SIXTH ADDENDUM TO INVITATION TO BID
FOR THE DURHAM WRRF PHASE 6B DIGESTER PROJECT NO. 7203

ISSUED: OCTOBER 24, 2025

Clean Water Services' Invitation to Bid for the Durham WRRF Phase 6B Digester Project No. 7203 dated September 17, 2025 (ITB) is hereby amended as follows:

SHEET TITLE: SITE DEVELOPMENT CIVIL DEMOLITION PLAN AREA 1

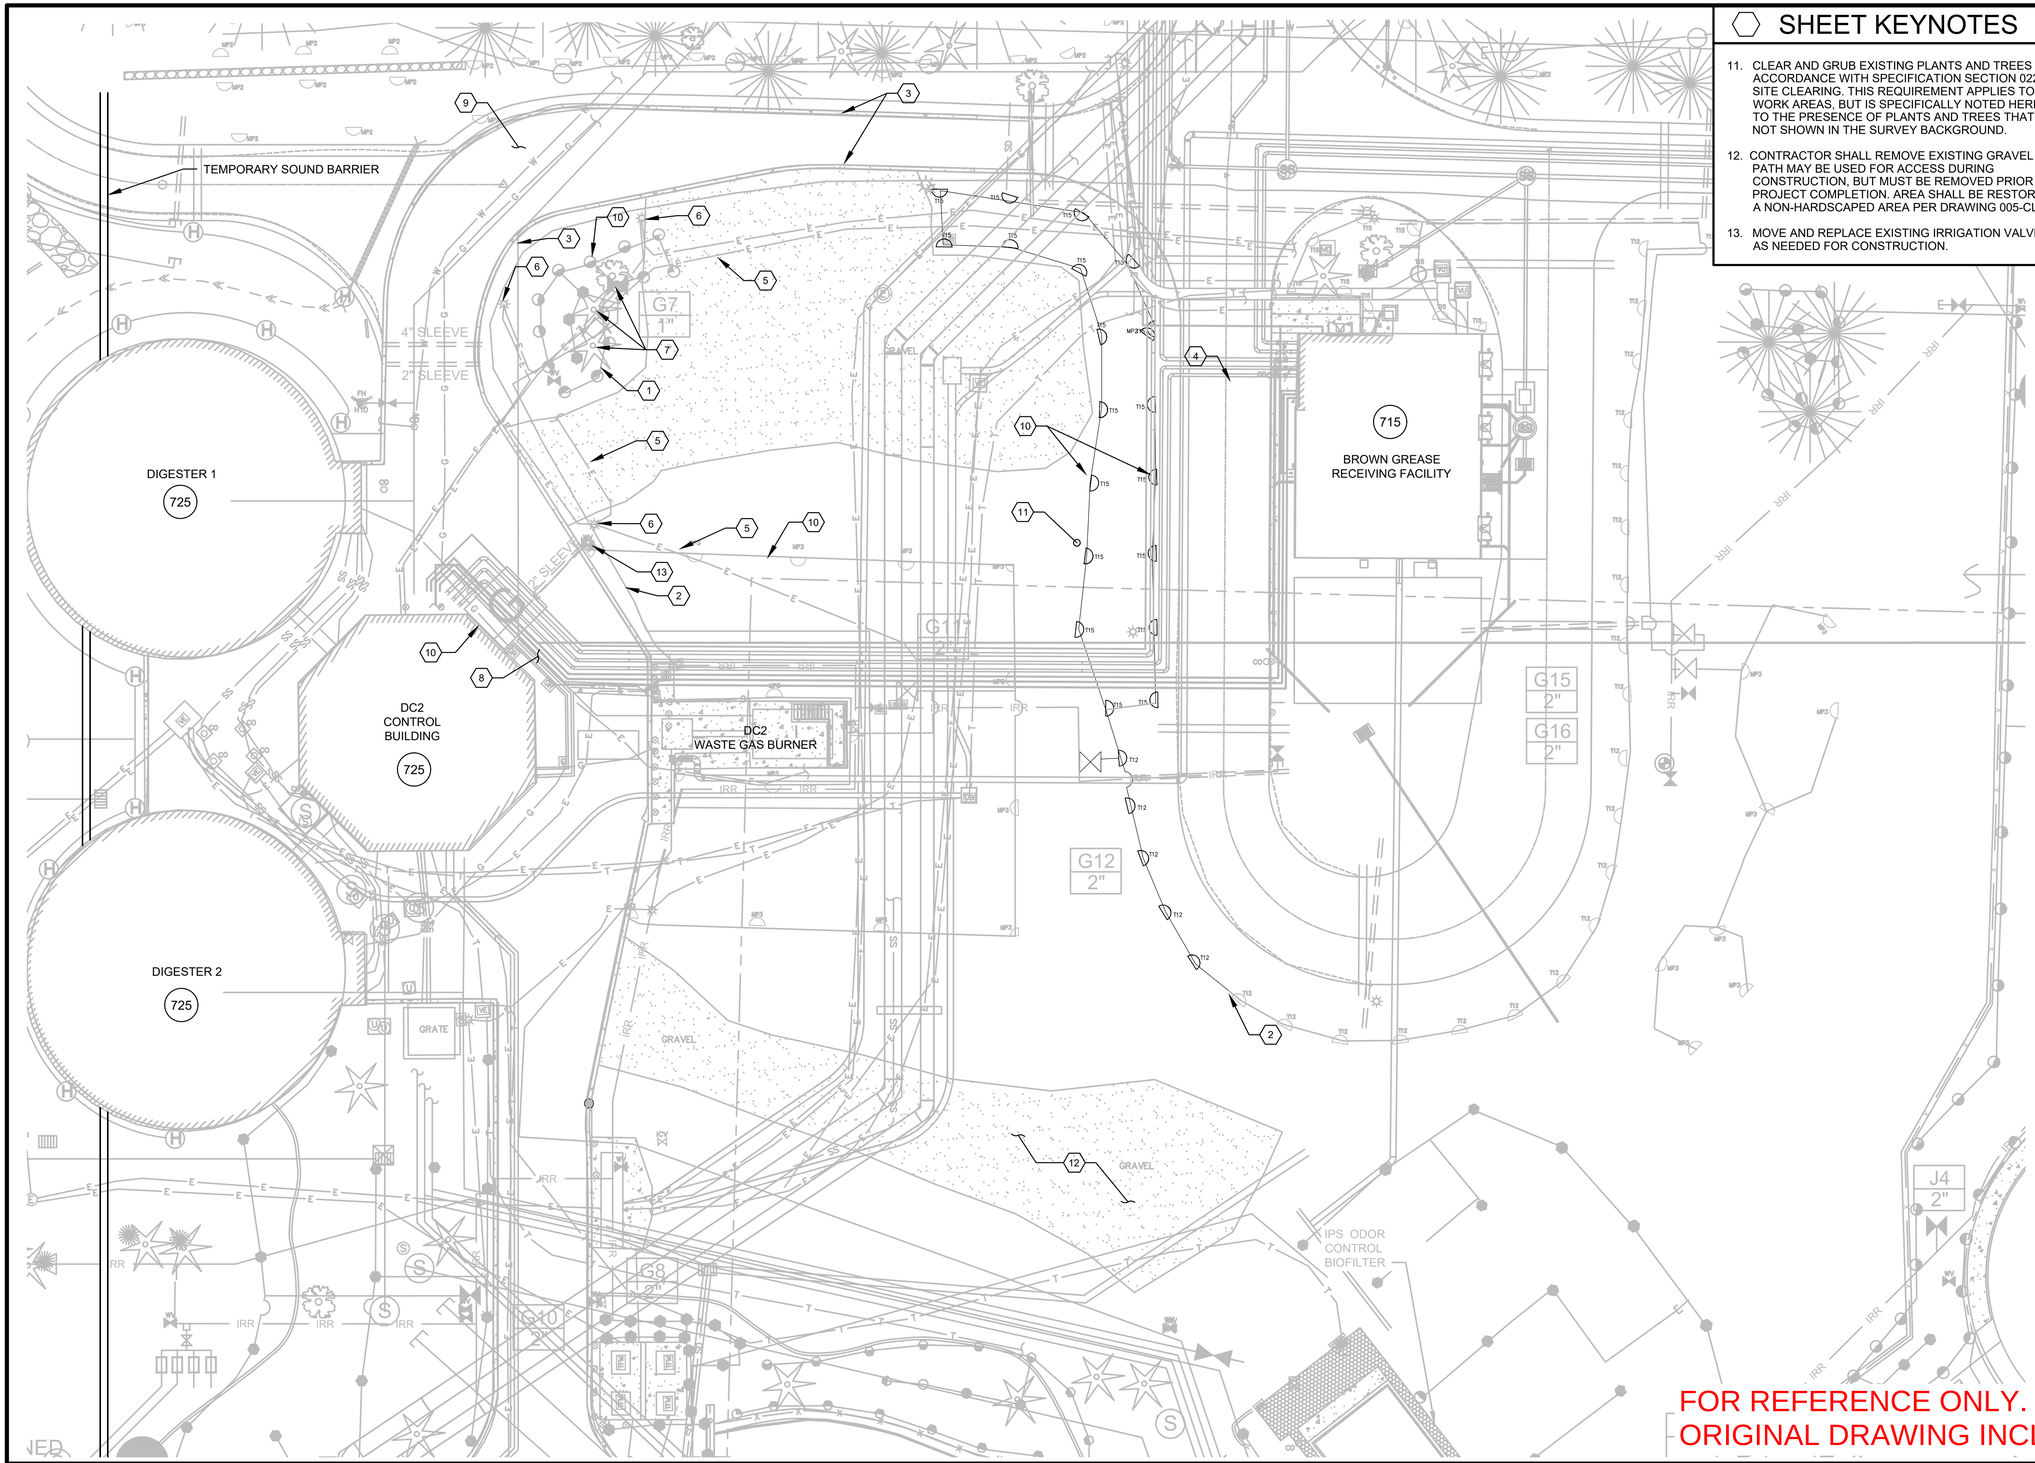
10. Question 10: Drawing 005-CD-101. Irrigation and electrical conduit are hard to make out with the X hatching. Can we get a page that removes the X hatching for conduit and piping demo.

Answer 10: Drawing 005-CD-101 is included in Exhibit B of this Addendum with the cross-hatching turned off for Bidder's use. This drawing is for reference only and does not supersede the original drawing included in 7203 - Volume 2 - Durham WRRF Phase 6B Digester Project Bid Drawings.
